**PUBLIC HEARING/WORKING SESSION MEMORANDUM**

**PETITIONS #91-21 & #27-20 (2) 355 and 399 Grove Street**

**To:** Jennifer Caira and Katie Whewell, Planning and Development Department, City of Newton  
**From:** Green International Affiliates, Inc. (Green)  
**Date:** May 7, 2021  
**Project Name:** Riverside Station  
**Project Number:** Green No. 18078  
**Subject:** Transportation Peer Review

**Figure I: Site Plan**

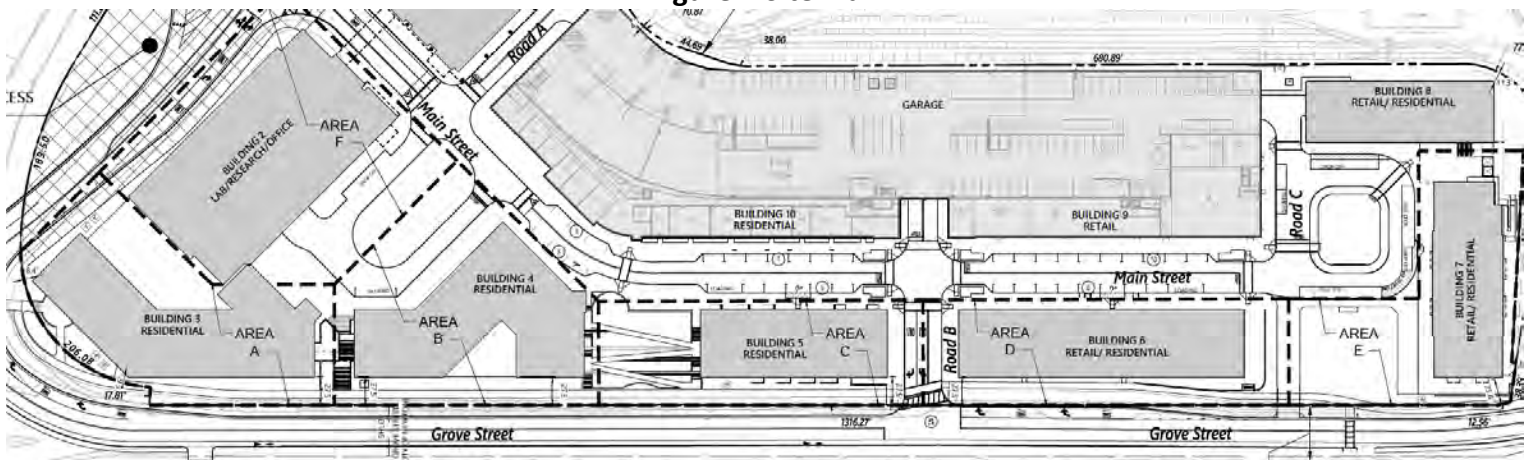
The petitioners propose to maintain the internal site circulation which consists of a general south-north path of travel through the site with Roads A, B, and C providing east-west access. Green noted a concern with queuing at the intersection of Main Street, Road B, and the entrance to the parking garage in Buildings 9 and 10. Specifically, vehicles exiting the garage seeking to access Grove Street may block the Main Street northbound approach and restrict access to the northern portion of the site and the transit station. The Petitioners intend to staff the parking garage and direct vehicles to other garage exits thereby reducing this concern. Such staffing plan was a requirement of Council Order #27-20 and will be carried forward into a revised Council Order, should this petition be approved.

Green also noted the proposed loading zone in the eastern portion of Road A in the open space formerly known as the hotel green. Green suggests the petitioners provide an evaluation of the proposed loading schedule and how it may affect peak hour traffic within the site or implement peak hour restrictions on loading and deliveries. Planning Staff requests more information regarding the specific delivery schedule and loading items for the intended laboratory and research uses for Building 2. Green also suggested loading zones for the buildings be shown on the site plan as well as turning
